Thank you for your email, whilst in principle the LHA have no objections to the application, there are further points with the proposed drawings which will need to be addressed before the LHA can advise that there are no highway safety concerns.

I have reviewed drawing 2405-P01 Rev D and whilst I note that the applicant has created a separate pedestrian access, crossing at the suggested location raises safety concerns due to its proximity to a bend. It would be more appropriate to direct pedestrians to the vehicle access point to cross over Ribchester Road as this falls within a straight section of road and provides better visibility than crossing near the bend. Therefore, a footway should be provided around the access point, a dropped kerb with tactile paving should be provided for pedestrians to cross at the access and it is expected that such a crossing will also be provided, at the expense of the applicant, on the opposite side to create a uncontrolled crossings point, the application will be expected to provide this under a section 278 alongside the access works. Similar to the below drawing as there is not a section of footway to connect to, I would look for a footway to cov

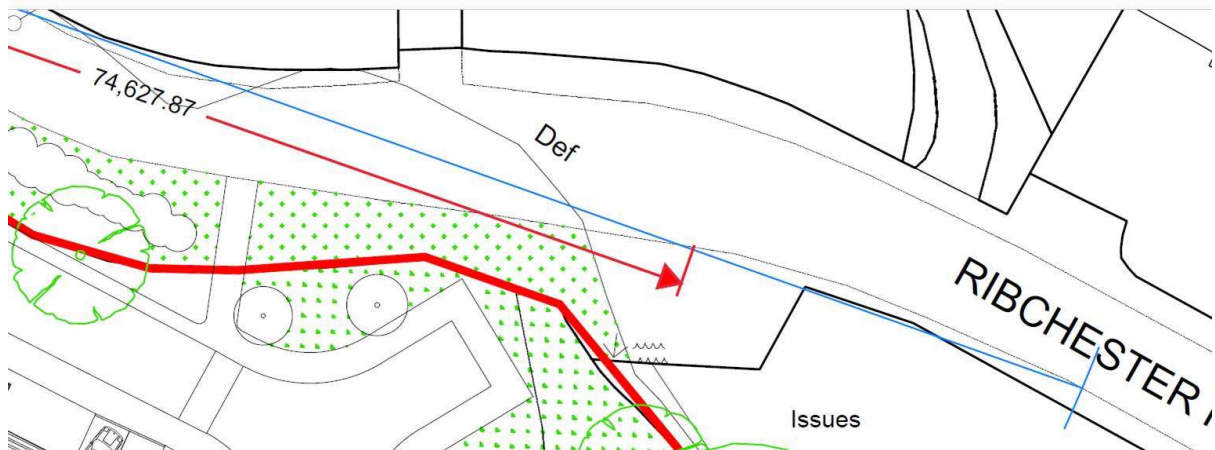
I have reviewed the visibility splay drawing 2405-V01 rev B, please can a blue edge drawing be provided showing that the cross-over in the below photo falls within the land the applicant controls? Any obstructions, fencing or vegetation which falls within the section will need to be removed/reduced in height to 0.9m. If this section does not fall within the applicant's land, then it would reduce the visibility splay and a speed survey will be required to measure the 85<sup>th</sup> percentile of traffic speeds along this stretch of road.
